ADA Curb Ramp New Construction Inspection Form (Perpendicular)

Nw 293rd

23885.56

Nw King

PERPENDICULAR RAMP (PR)

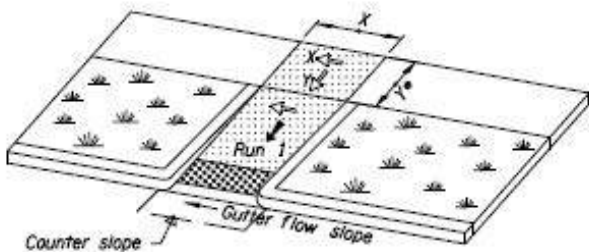
Tool joint in TS
